Response IX.A: Changes to Draft Permit Conditions for the Final Permit

6. EPA's Revised BPJ Determination of BTA for the Final Permit

Response to Comments - Figure 3

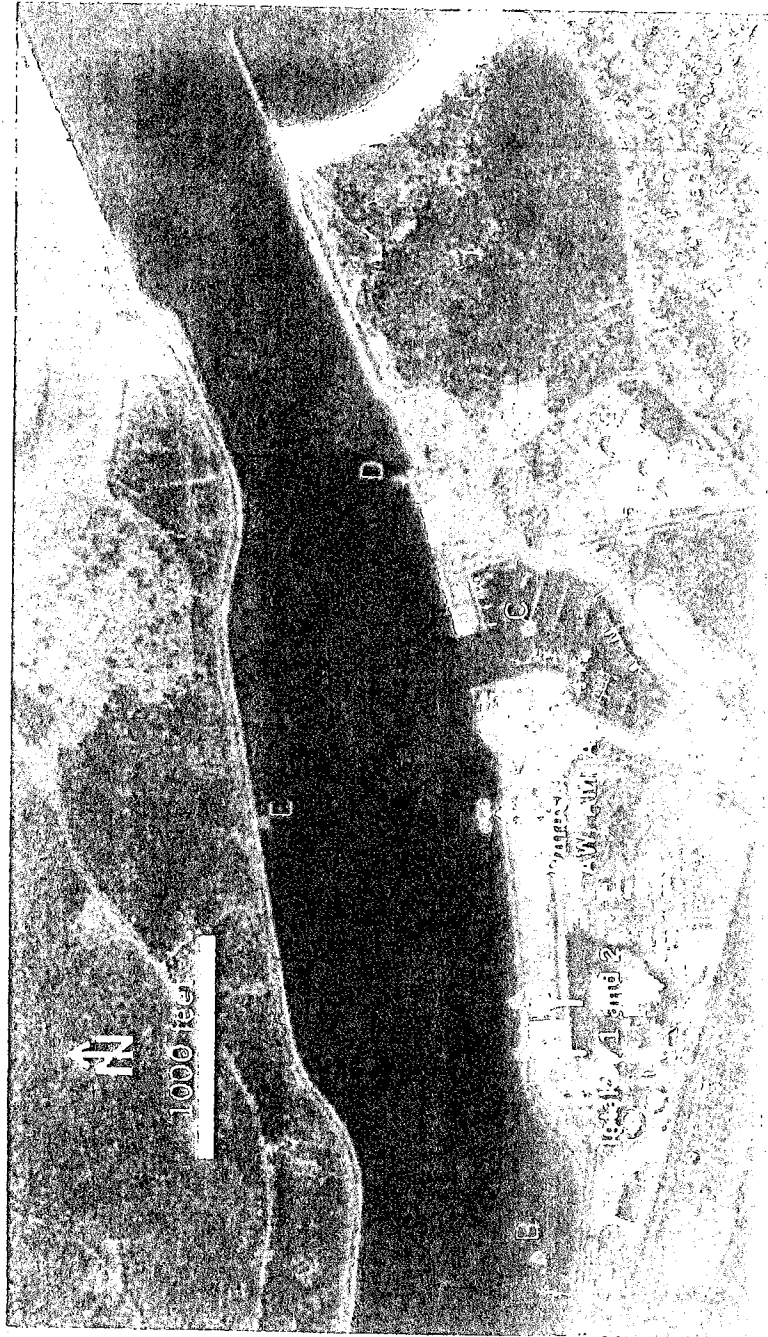
EPA has determined that the thermal discharge from Canal Station will not adversely effect benthic EFH. The thermal plume from Canal Station has been delineated during past operation using fixed station thermistors and measurements from a boat survey. EPA did not attach these results to the Draft Permit's Fact Sheet. However, EPA has attached these results to this Responses to Comments document as Figures 1 through 3. The figures show that the thermal plume has limited contact with the sea floor. Since the thermal plume is positively buoyant, it is expected to have little contact with the bottom. EPA has explained its assessment of this issue to NMFS, which indicated it had no objections to EPA's conclusions.
